Model	Thunderbird II LCT	Volt/Hz	Date of Modification	Serial Number
Modified Article	LCT Caution Decal			
Reason for Modification	Part Catalog Correction

Model	LCT for Thunderbird II	Volt/Hz	Date of Modification	Serial Number
Modified Article	Misfeed Removal Decal			
Reason for Modification	To reduce operation errors

Model: LCT for Thunderbird 2		Date: 31-May-97	No: 5
Modified Article: Clutches		Prepared by: M.Mimura	
From: QAC 1st Field Information Dept.			
Reason for Modification:	<input type="checkbox"/> Parts catalog correction	<input type="checkbox"/> Vendor change	<input type="checkbox"/> To meet standards
	<input type="checkbox"/> To facilitate assembly	<input checked="" type="checkbox"/> To improve reliability	()
	<input type="checkbox"/> Part standardization	<input type="checkbox"/> Other

Model: LCT for Thunderbird 2		Date: 15-Jul-98	No: 6
Modified Article: Parts Catalog		Prepared by: H.Kobayashi	
From: QAC Field Information Dept.			
Reason for Modification:	<input checked="" type="checkbox"/> Parts catalog correction	<input type="checkbox"/> Vendor change	<input type="checkbox"/> To meet standards
	<input type="checkbox"/> To facilitate assembly	<input type="checkbox"/

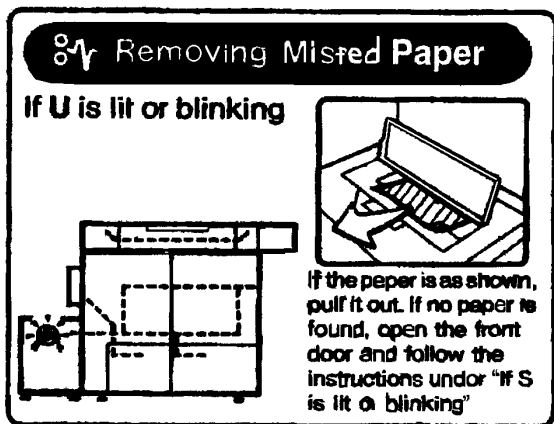
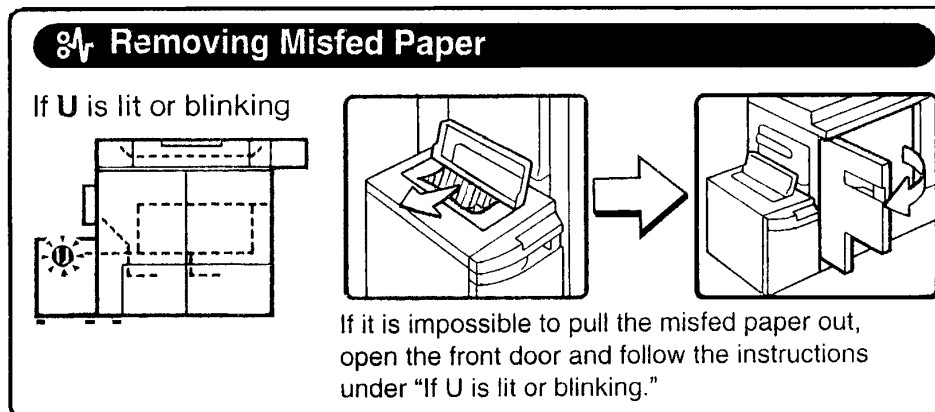
Due to a suggestion from the field, the misfeed removal decal has been changed to improve user guidance.

Old P/N	New P/N	Description	Q'ty Used	Inter-change-ability	Parts Catalog	
					Index No.	Page
AA000170	AA000185	Decal - Misfeed Removal	1 → 1	X/O	2	15

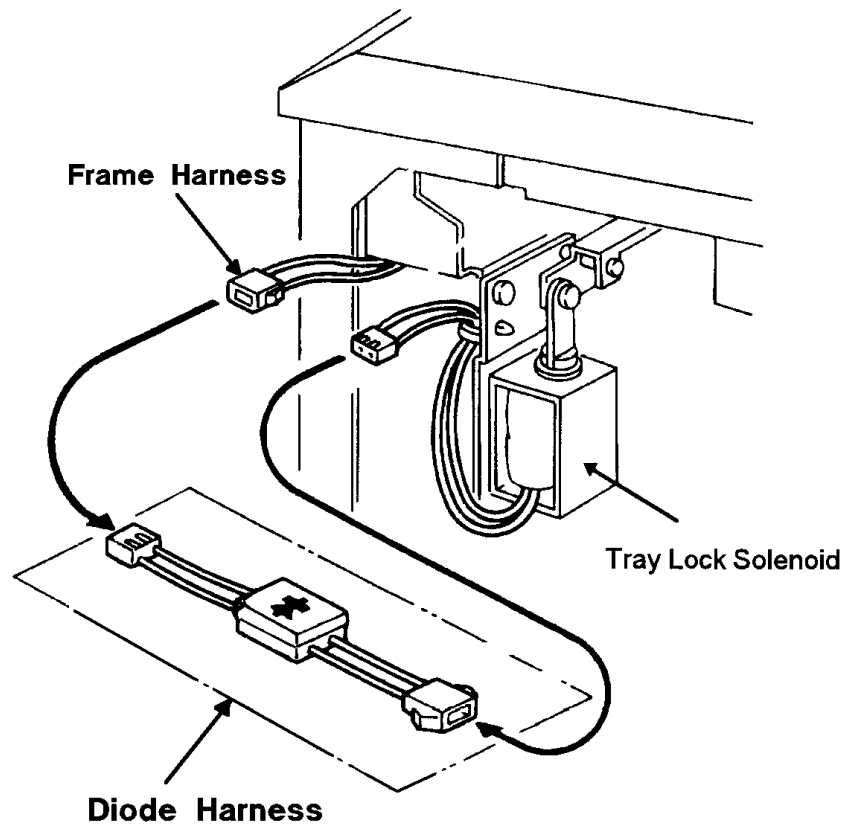
To filter out the electrical noise from the tray lock solenoid, the diode harness has been added. The color of the frame harness connector has been changed from white to blue to match its color with the facing connector of the diode harness. For field troubleshooting information, refer to RTB # 008.

Model	LCT for Thunderbird II (-22, -26, -27 version only)	Volt/Hz	Date of Modification	Serial Number
Modified Article	Ferrite Core			
Reason for Modification	To increase the electrical noise tolerance to conform with the CE mark standards

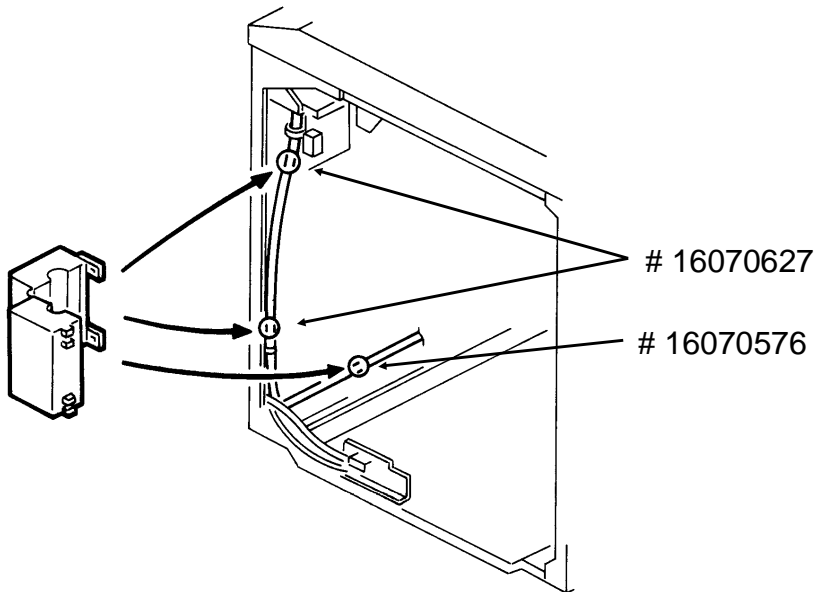
For the reason mentioned above , three ferrite cores have been added as shown.

New P/N	Description	Q'ty Used	Parts Catalog	
			Index No.	Page
16070576	Sleeve Core - SFC-8	0 → 1	115	5
16070627	Ferrite Core - SFC-10	0 → 2	116	5

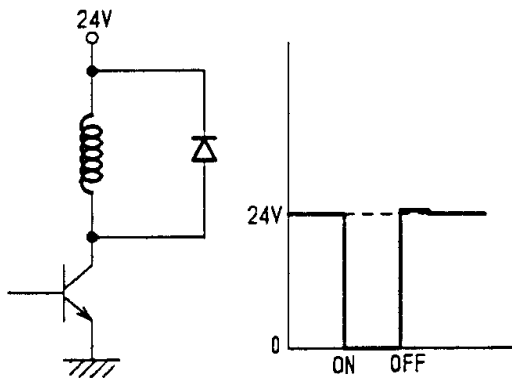
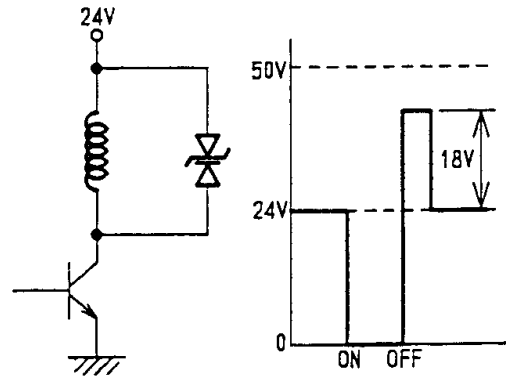
If the disengagement of the clutch is physically delayed, the paper may occasionally be overfed, reaching the relay roller. This may lead to jams and/or Z-folding in the registration area.

To ensure quick clutch disengagement, a zener diode has been installed in the clutch connector. (Current clutches have a diode in the connector.) The zener diode will reverse the magnetic field to force the armature to be released quickly when the clutch is electrically de-energized.

Old part number	New part number	Description	Qty	Int	Page	Index	Note
AX200121	AX200145	Magnetic Clutch	1	X/O	9	57

Page 8

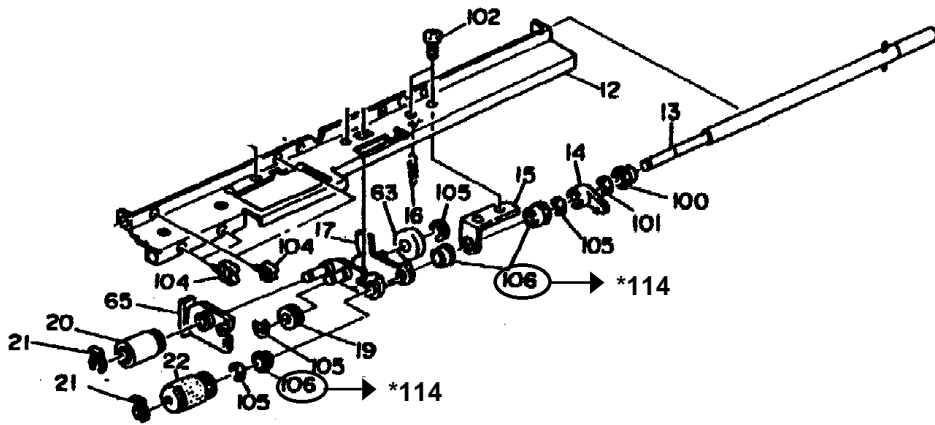
1.Illustration correction

Please correct the illustration in your parts catalog as shown.
